Our Ref: Q26104
Your Ref: MCUI/35/2026
Caroline Milne

21 August 2026

RESPONSE TO ASSESSMENT MANAGER'S INFORMATION REQUEST
DEVELOPMENT ASSESSMENT RULES 2017 PART 3 S13
DEVELOPMENT APPLICATION FOR A DEVELOPMENT PERMIT FOR MULTIPLE DWELLING DEVELOPMENT
38 TIMOR AVENUE, LOGANHOLME
(LOT 297 RP118026)

Figure 1: Parks within a 20-minute walkable catchment of 38 Timor Avenue (Source: Heart Foundation)

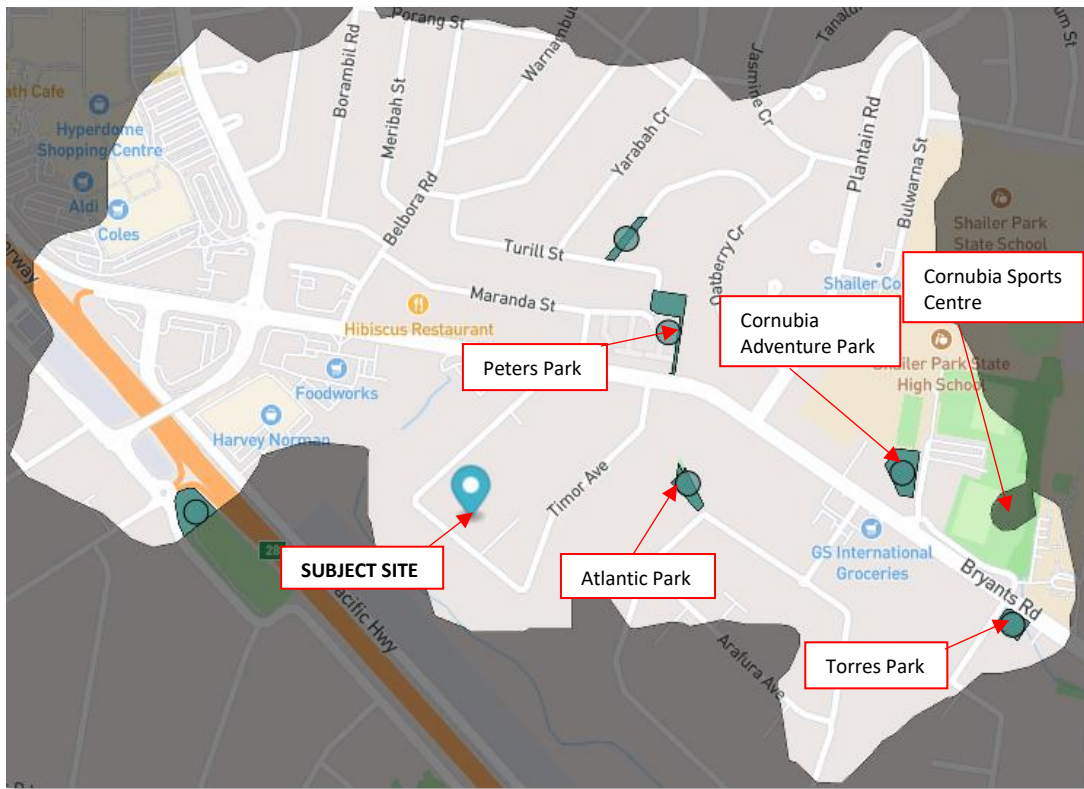
1.4 Submit a contextual analysis plan analysing accessibility of parks within the walkable catchment of the site and the embellishments and recreation opportunities associated with each.

We further add the following detail to this discussion, with the following parks within a 20 minute walkable catchment depicted in **Figure 1** overleaf:

- Peters Park – a playground and green space;
- Atlantic Park – which includes a playground and green space;
- Cornubia Adventure Park – a playground and basketball courts;
- Torres Park – a garden and green space; and,
- Cornubia Sports Centre – indoor sports and recreation, football, tennis and netball facilities.
